***Re:*** ***Addendum No. 1***
***WWTP & LS Improvements***
***Contract A – WWTP Improvements***
***Contract B – Brooklyn Street LS Improvements***
***City of Port Clinton, Ohio***

Date: October 16, 2026

PROJECT NO: 33943
DRAWING NAME: 10C-03
SHEET 9 OF 31

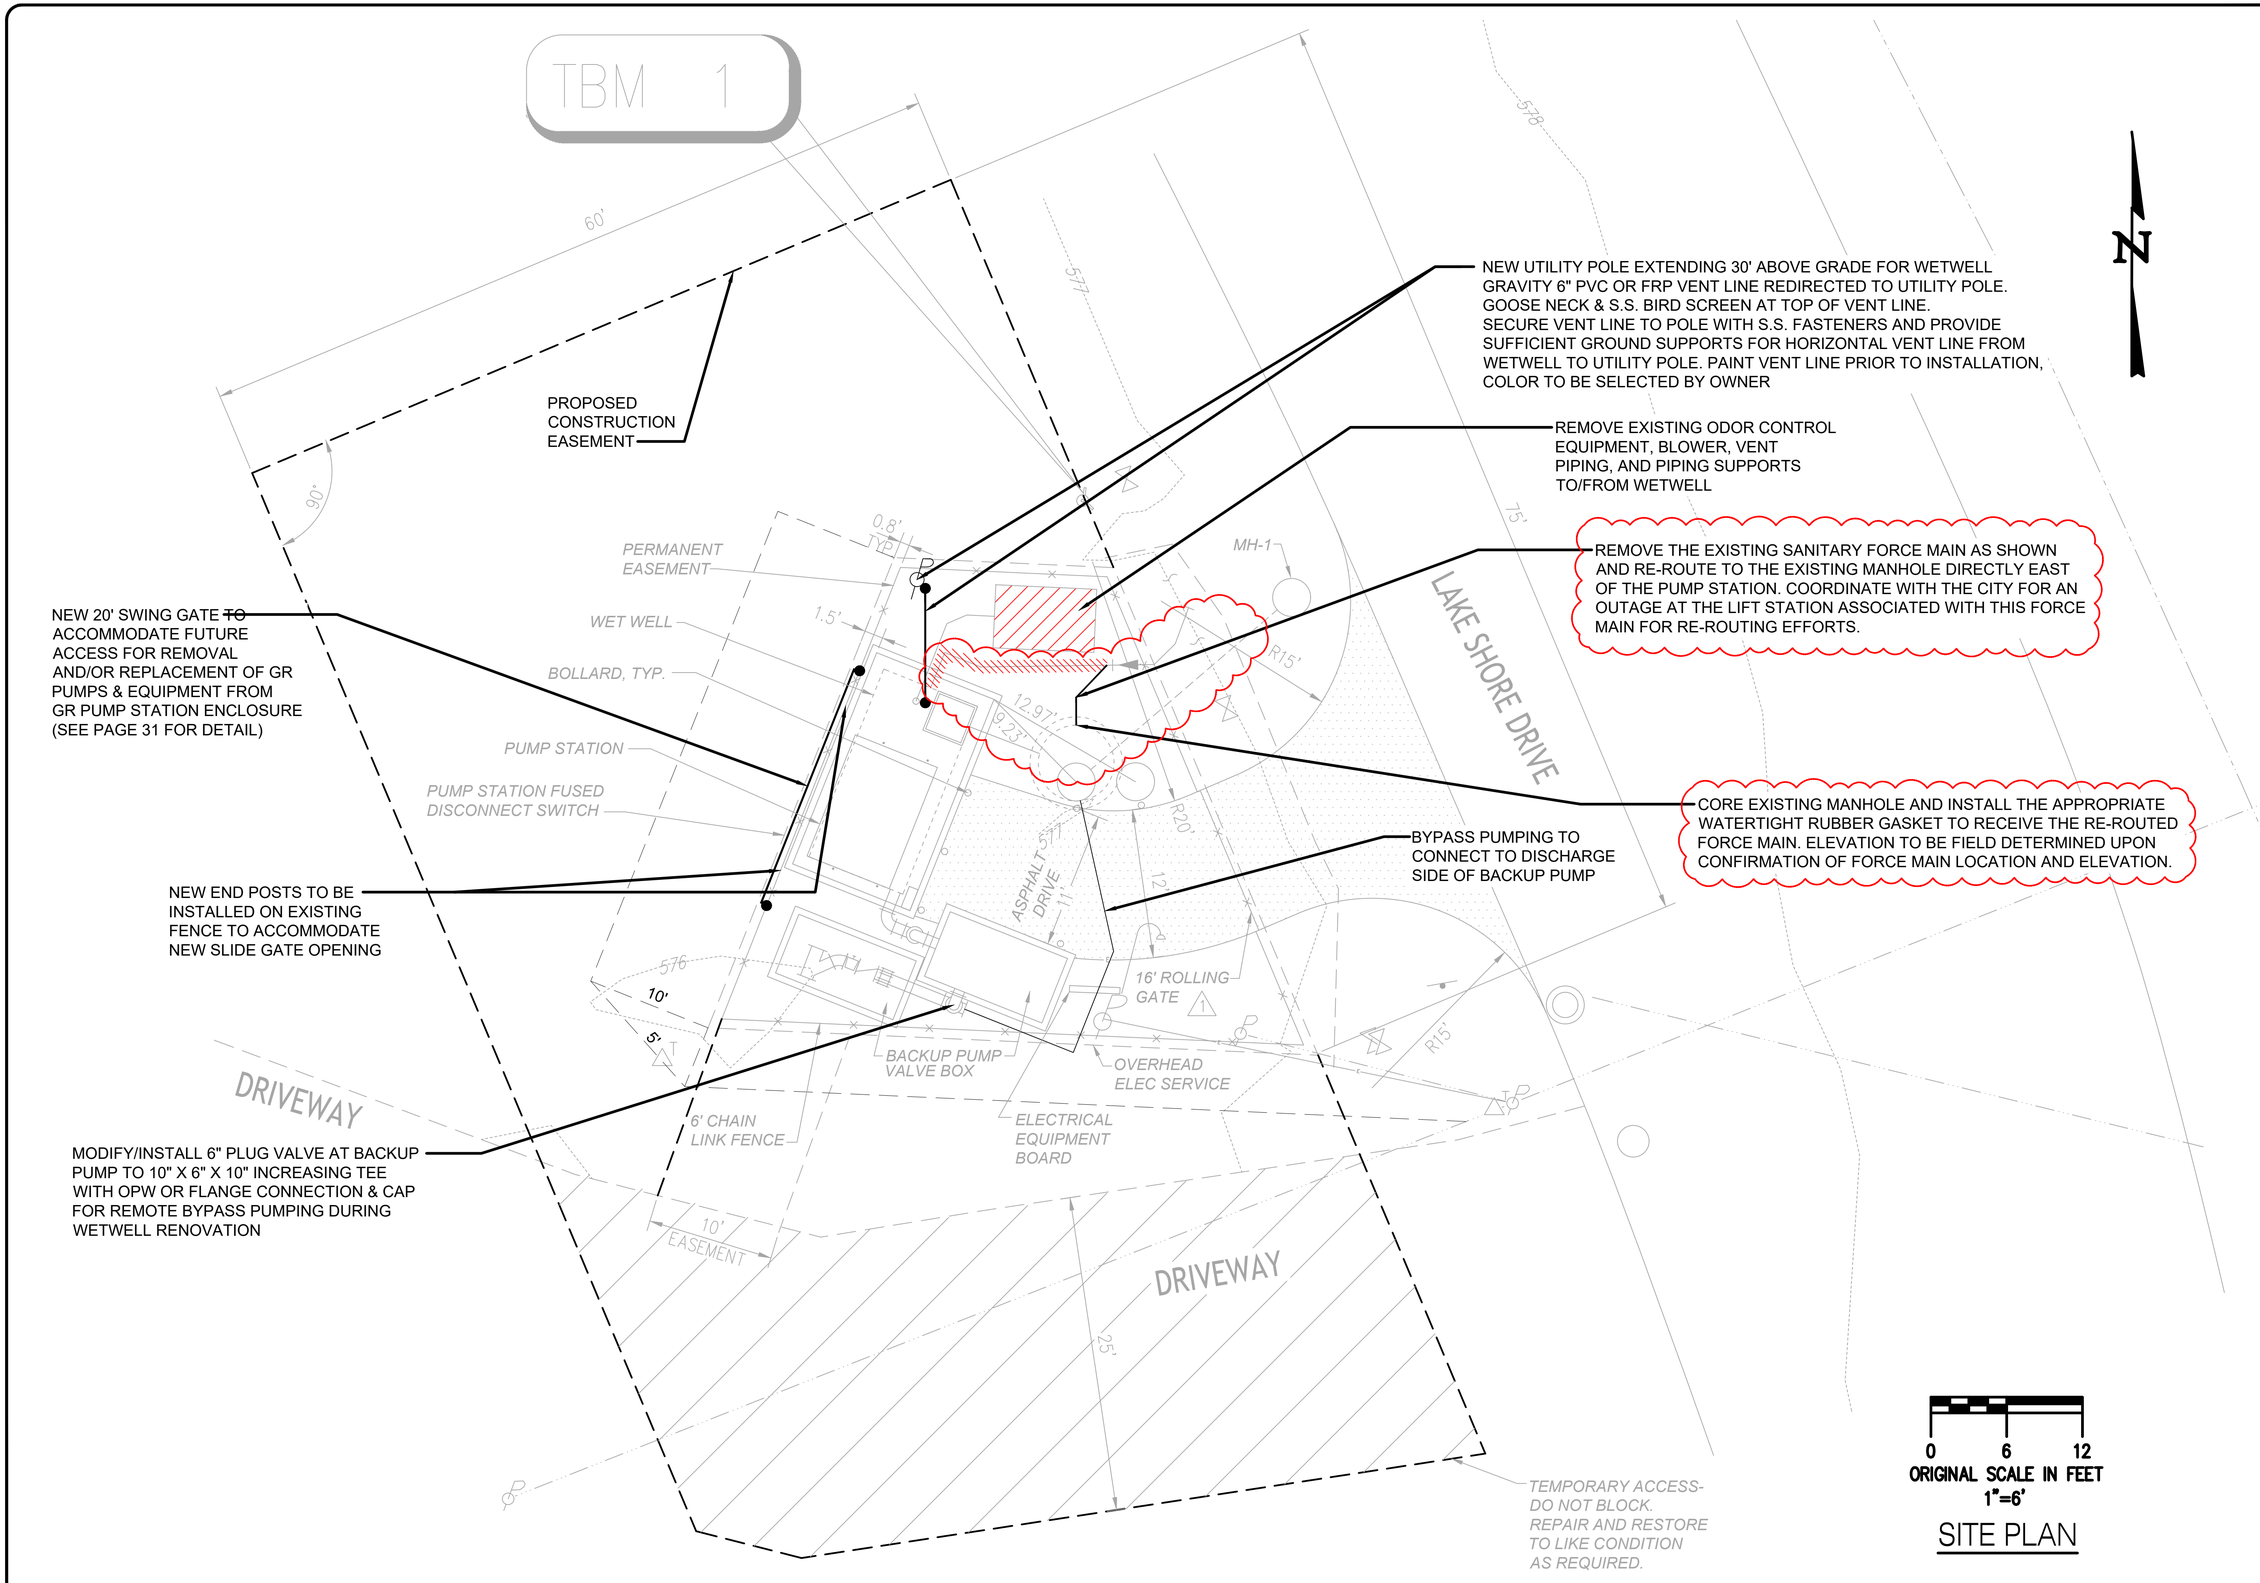
Q3. Drawing 10C-03 indicates that there is a utility pole that is to be installed on the NW corner of the site. Is the utility company setting this pole or is the Contractor responsible for setting the pole?

A3. The Contractor is responsible for setting this pole. For clarity, the use of the term "Utility Pole" is general for this application, the type and style of pole only needs to accommodate and

support the re-routed vent pipe from the Lift Station. It will not need to support any public or private utilities.
